GOLDEN GATE BRIDGE  
PHYSICAL SUICIDE DETERRENT SYSTEM  
FEDERAL-AID PROJECT: BHLS-6003(051)  
and  
WIND RETROFIT  
FEDERAL-AID PROJECT: BHLS-6003(052)

Contract No. 2016-B-1

RE: **Response to Bidders' Question No. 286 through 306**

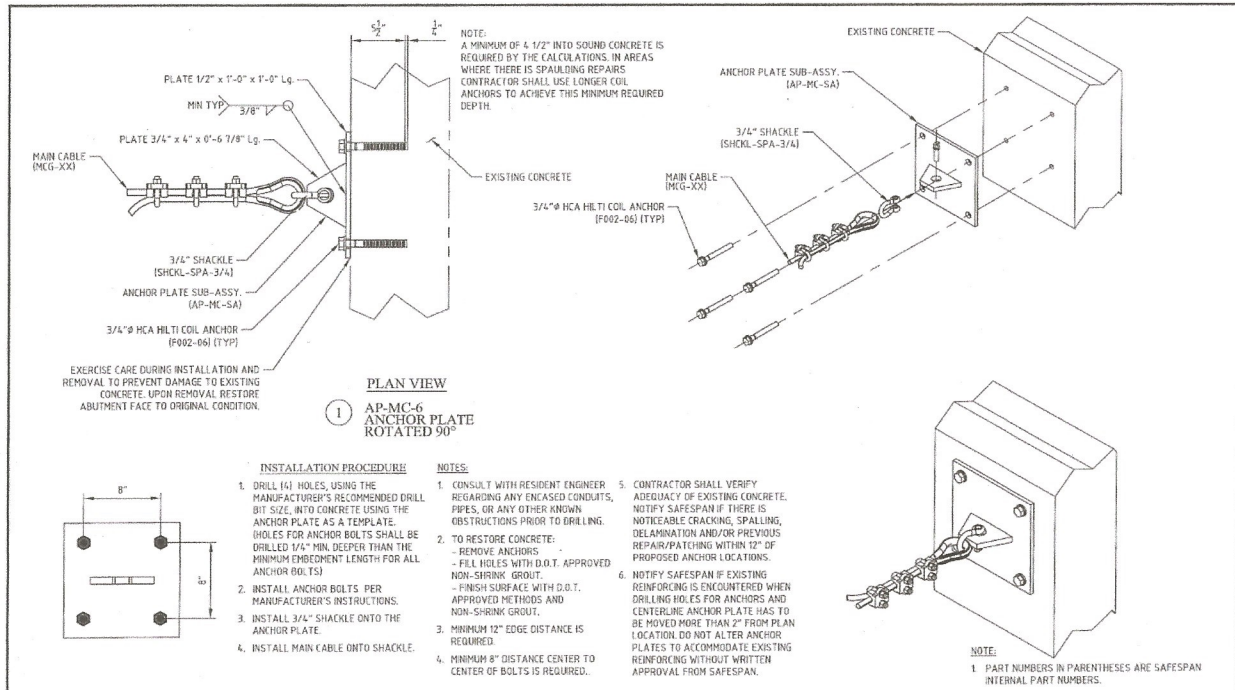
The fifth paragraph of **Section 7-1.0K Builder's Risk / Course of Construction Insurance** begins, "*The District will reimburse you for the actual cost of the Builder's Risk Insurance, excluding any commissions (indirect or direct, including contingent commission compensation)...*"

Please confirm the District will pay the invoiced amount. Specifically, if there are administrative, indirect, fees, commissions, or profits from the broker or the insurance company (included in the total, but NOT itemized), these amounts will not be later audited and withheld from payment. The Contractor assumes the full amount invoiced and required to be paid by the Contractor will be reimbursed, as is the industry standard.

*The District will reimburse the actual premium retained by carrier plus the standard retail and/or wholesale commission expense paid by the carrier to an intermediary broker to secure the required coverage. The District will not allow fees not specific to the placement of the required coverage, or any indirect, or contingent commission. Since this project is partially funded with federal funds, it is subject to audit.*
